# VALIDATION OPINION FOR REVISION OF REGISTERED MONITORING PLAN

***Tambun LPG Associated Gas  
Recovery and Utilization Project***

**UNFCCC Ref. No. 1144**

| Validation opinion for revision of Registered Monitoring Plan                |              |   |  |

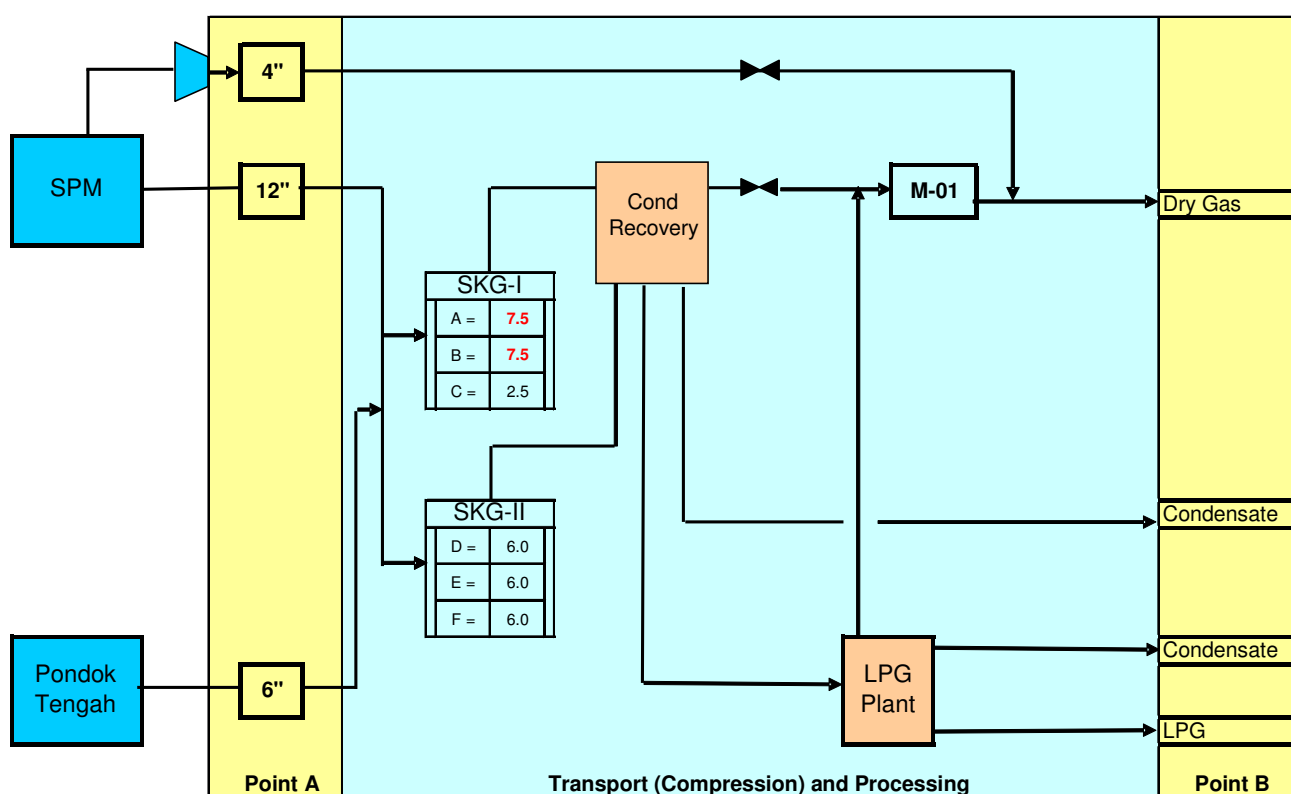
1. How the PP/DOE define the CDM project boundary. Please provide a schematic diagram.
2. How the DOE validated the increased associated gas of Tambun compared to the estimates

The diagrammatic representation of project boundary is as shown in the PDD and is reproduced below. It also shows the AM0009 Measurement Points. The blue boxes labelled SPM and Pondok Tengah represent the two oil fields:

Note 1: - Fuel gas used for compression upstream of the 4" input measurement is from the condensate plant fuel gas header and is therefore accounted for within the PECO2 Point A-Point B balance.

Note 2: - PECO2 balance calculation uses measurement of Dry Gas from orifice meter M01, rather than total pipeline flow. As per Note 1, there are no PECO2 emissions associated with the 4" bypass

RE 1: The Project boundary displayed in Figure 4 of the section B3 in the registered PDD remains unchanged. The PP has clarified that the two oilfields are represented by the blue boxes labelled SPM (Tambun) and Pondok Tengah respectively. The figure is reproduced in section 4.2 below. The text immediately below figure 4 in the PDD states as follows:

The project boundary is same as mentioned in registered PDD. The only change is as i.e. on 31 March 2008 the contract for gas from the Pondok Tengah field was terminated and no gas has been supplied through the 6" pipeline since then. This pipeline has been disconnected, and changes to the Monitoring Plan are requested accordingly. Due to this fact, Odira continued to process Tambun gas in the condensate plant under the "excess gas" clause of the contract. Despite this additional processing, Pertamina continues to flare untreated gas from the Tambun field since the beginning of the project. This activity is therefore only partially reducing flaring activities from oil fields that have already been in operation before registration of the CDM project.
